# Technical Service Information

## FORD 4R100 "PWM" AND "NON-PWM" PUMP DIFFERENCES

Figure 1

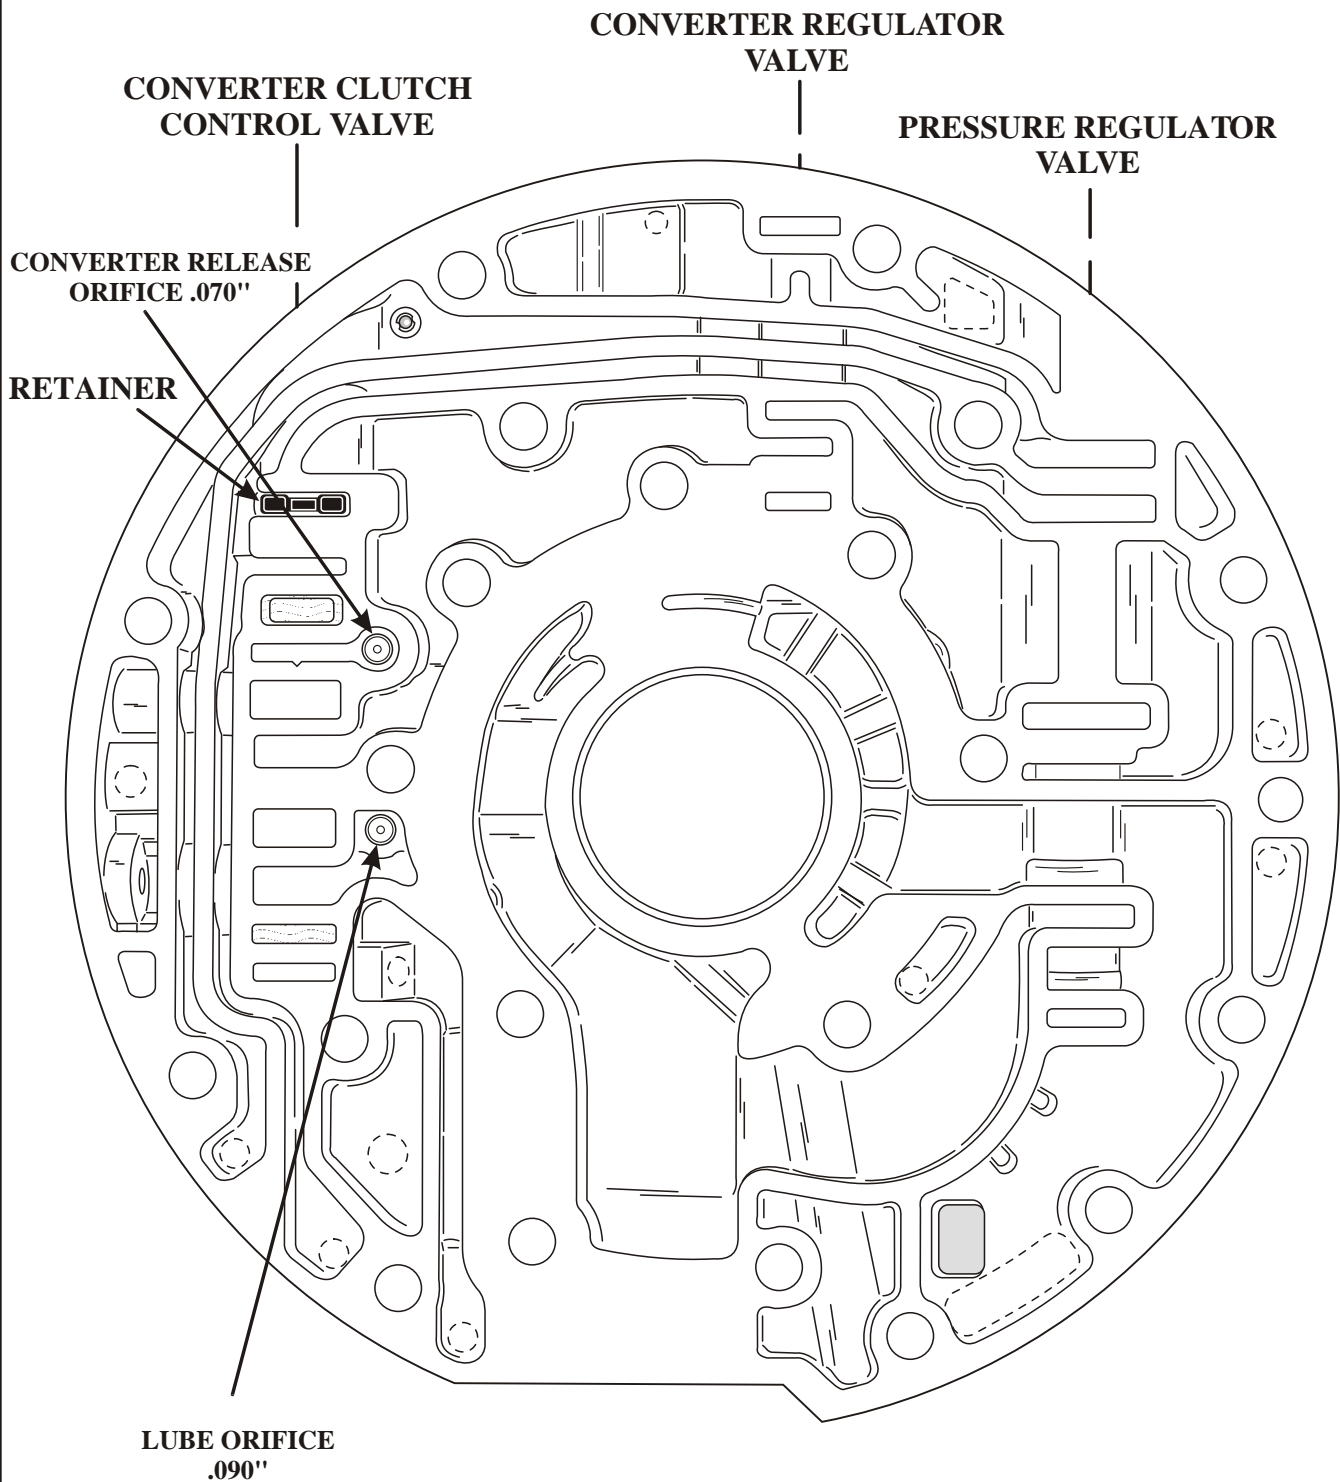
- The pump cover assembly had the rear of the Converter Clutch Valve bore enlarged approximately .070" to accommodate the enlarged land of the Converter Clutch Valve as shown in Figure 3. A .036" orifice and an air bleed were added to the TCC Solenoid signal passage as shown in Figure 2.
- The Converter Clutch Control Valve's rear spool was enlarged approximately .070." There was also a bushing and valve added to the end of the valve train as shown in Figure 3. A hole was added to the pump cover to connect the Converter Clutch Control Valve Bushing to Converter Regulator Valve oil, as shown in Figure 2.
- The Converter release orifice in the NON-PWM pump cover, as shown in Figure 1, was removed from the PWM pump cover as shown in Figure 2.

Figure 3

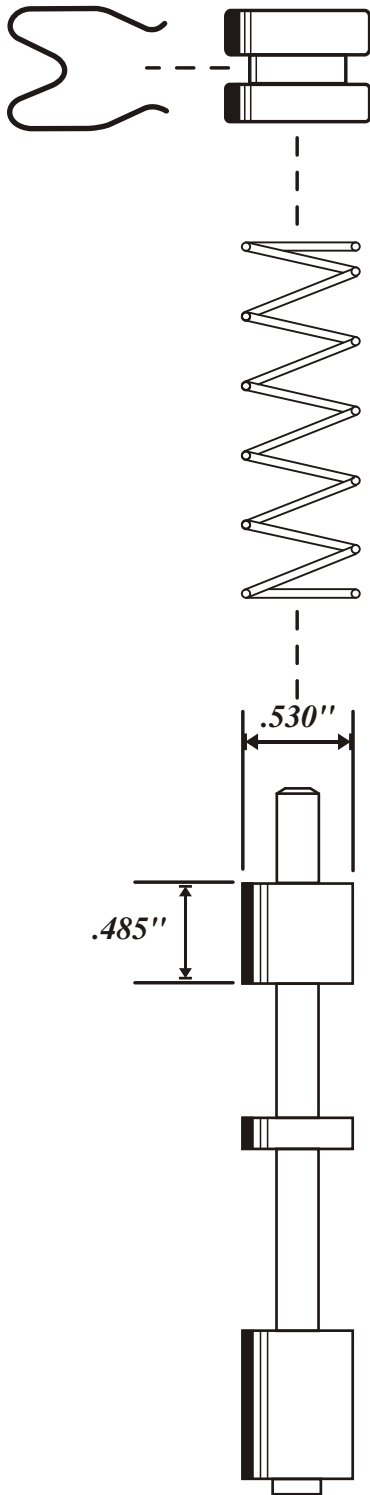
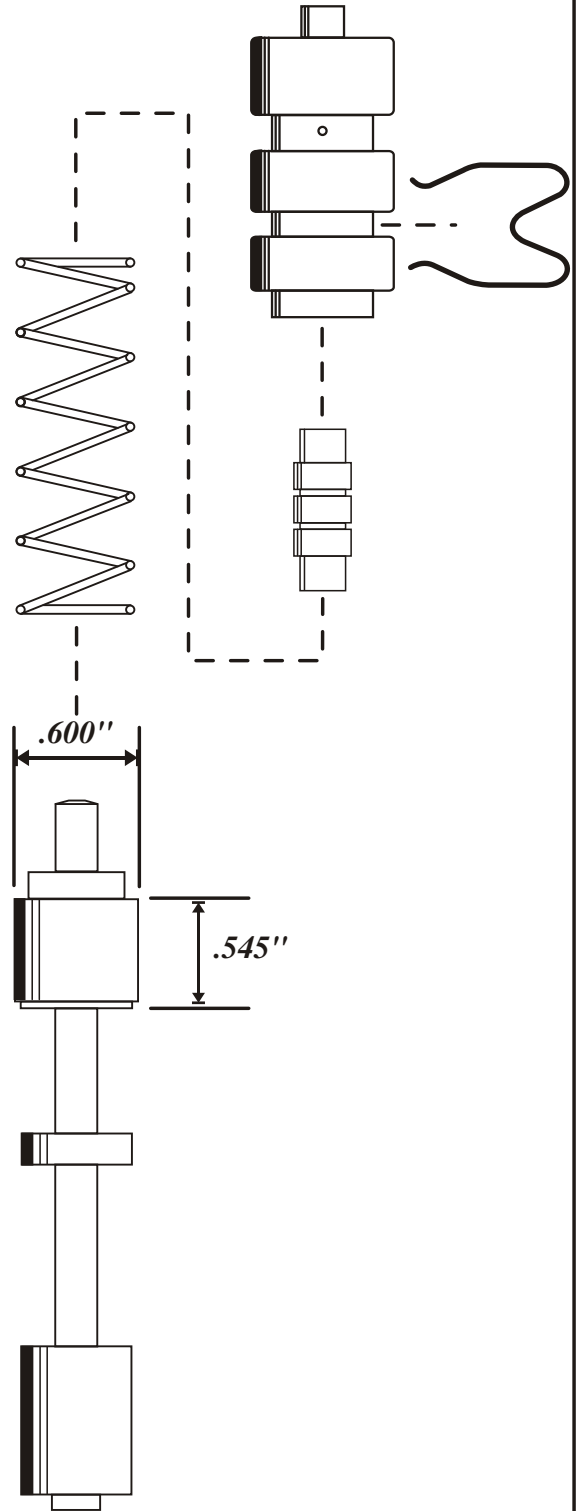
*THE DIAMETER AND THE LENGTH OF THE SPOOL ON THE VALVE LAND SHOWN ABOVE, WERE INCREASED ON PWM VERSIONS. THE BORE IN THE PUMP WAS ALSO ENLARGED APPROXIMATELY .070" TO ACCOMMODATE THE CHANGES IN THE DIAMETER OF THE VALVE*

Figure 4

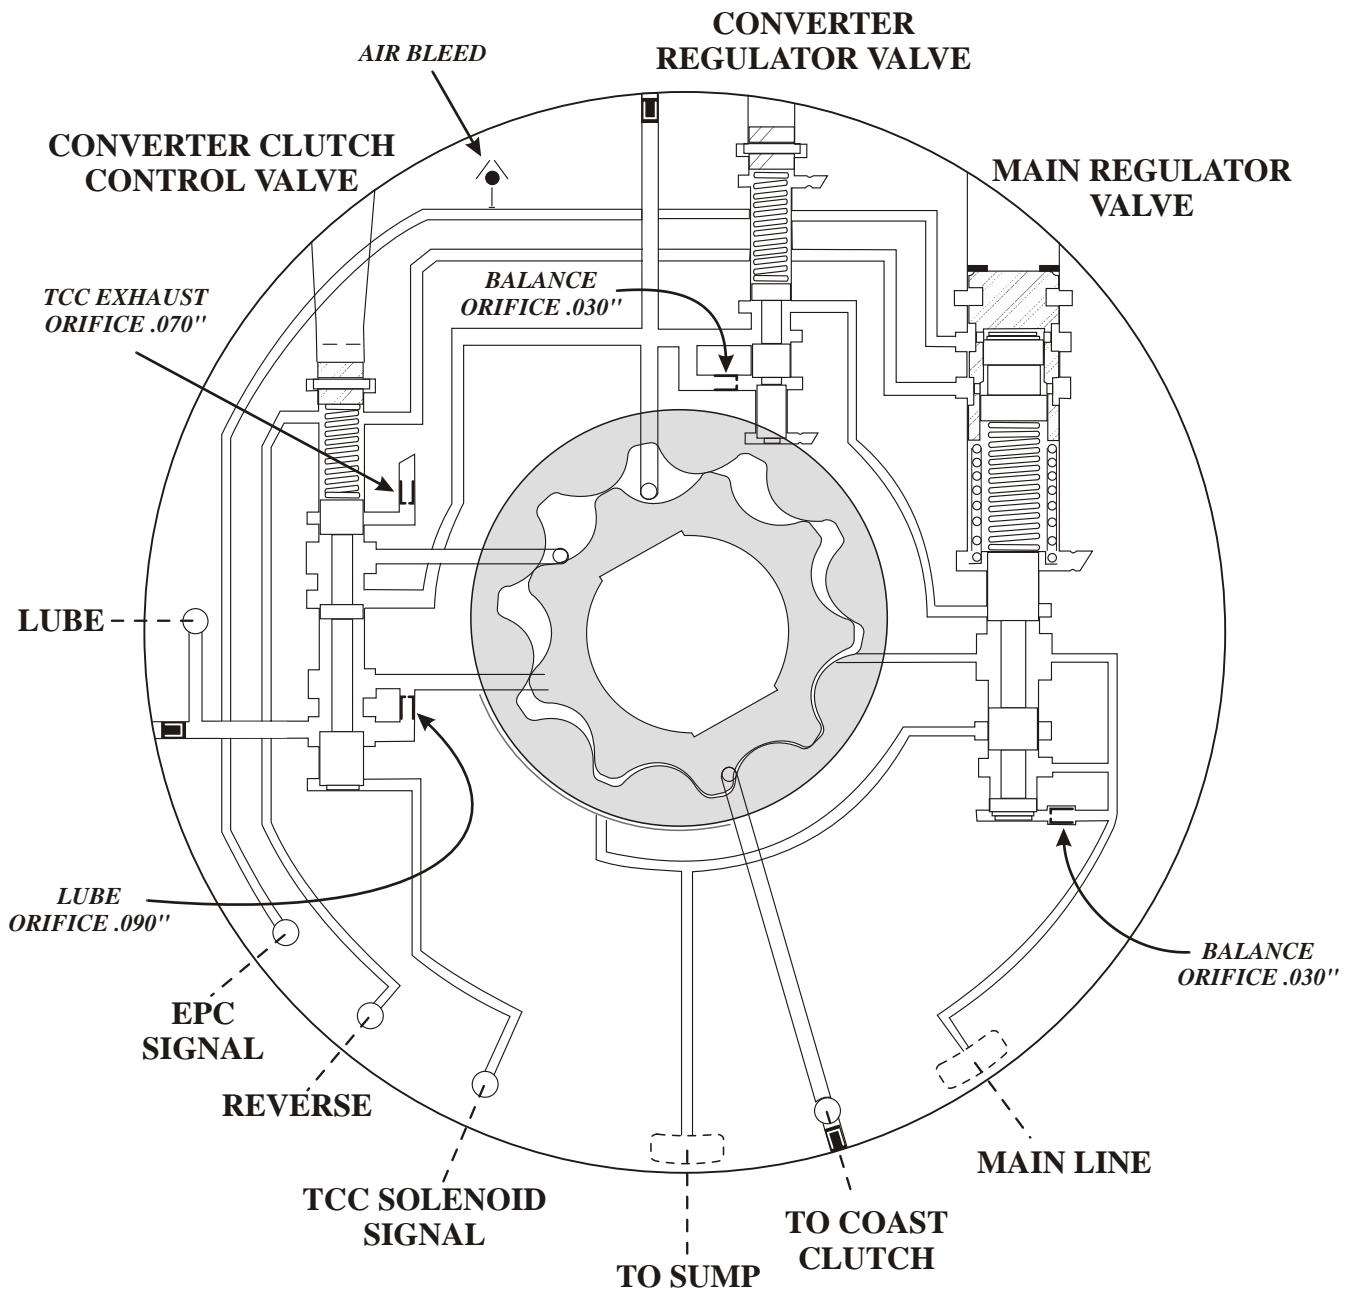
*Refer to Figure 4 for the NON-PWM pump hydraulic circuit.*

Figure 5

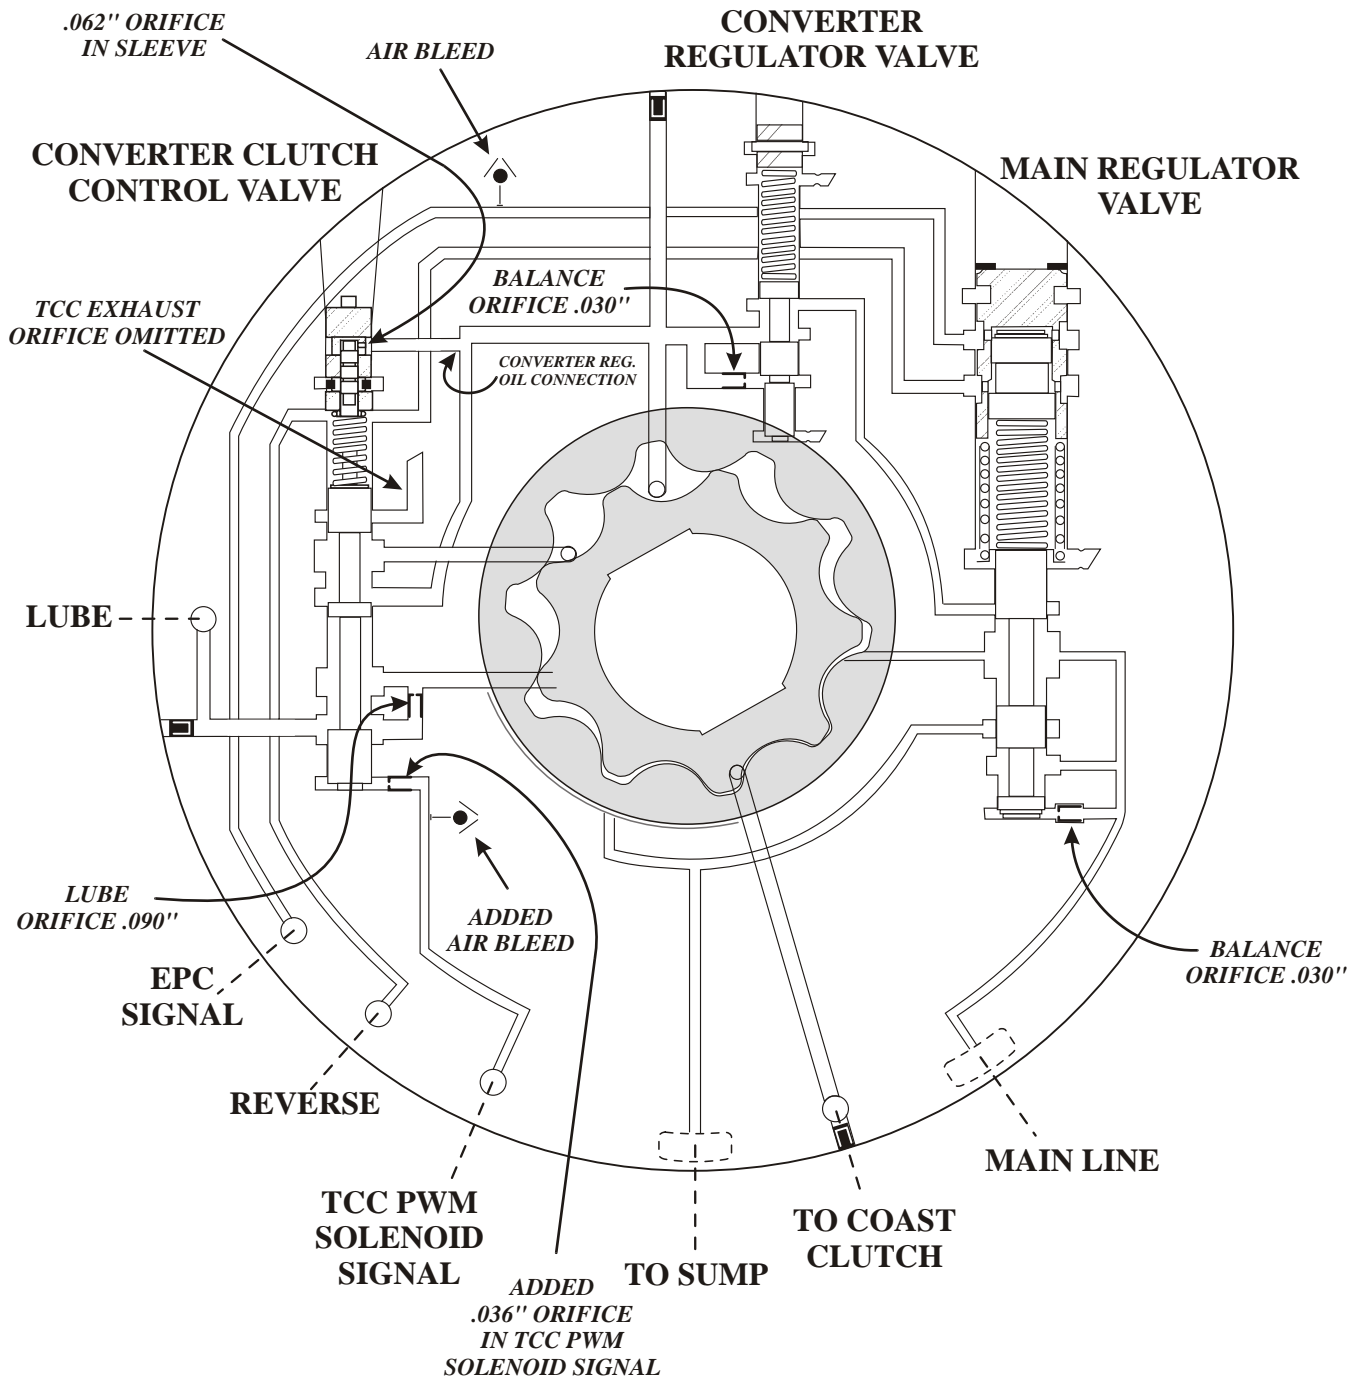
*Refer to Figure 5 for the PWM pump hydraulic circuit with all of the hydraulic changes shown.*

Figure 6

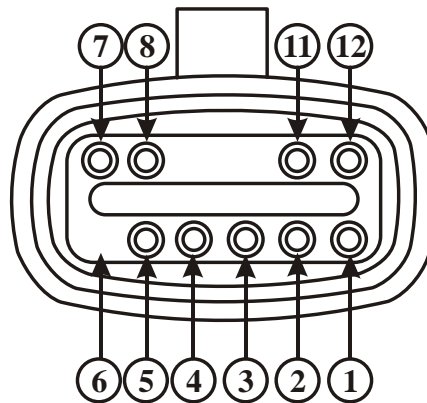
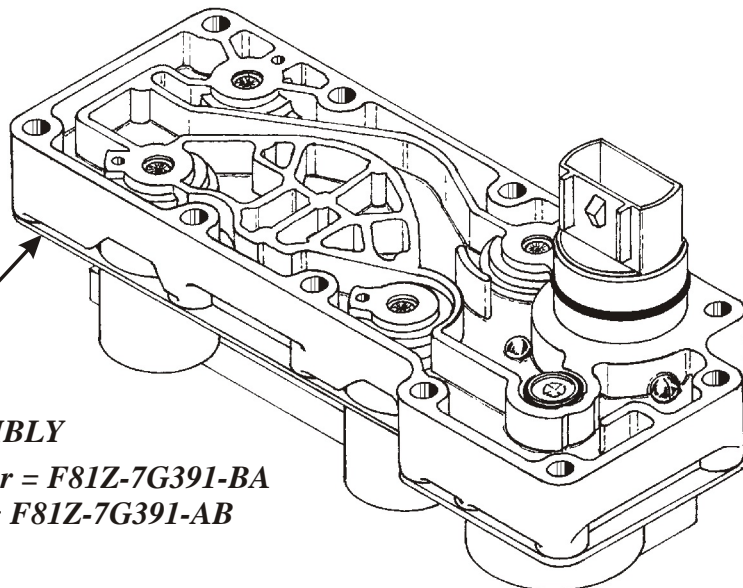
- The PWM solenoid pack requires a Pulse Width Modulated torque converter clutch solenoid and
- (2) the NON-PWM solenoid pack requires an on-off torque converter clutch solenoid. *Refer to Figure 6 to identify the differences between the two solenoid packs.*

"NON-PWM" versions - Part Number = F81Z-7G391-BA

"PWM" versions ----- Part Number = F81Z-7G391-AB
